Building Stabilization Plan Review

St. Paul's School Garden City, NY

Issued for Review: December 17, 2010
L&M File No.: 10-0929-00

Figure 2

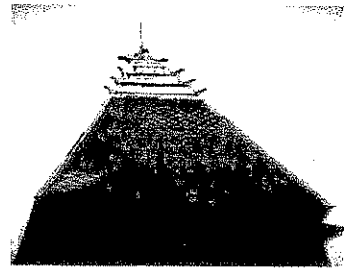
The existing roof system on the mansard roof areas are constructed of asphalt shingle (figure 2) – this system is not the original system; which was most certainly slate shingle as it still remains on the clock tower (figure 3).
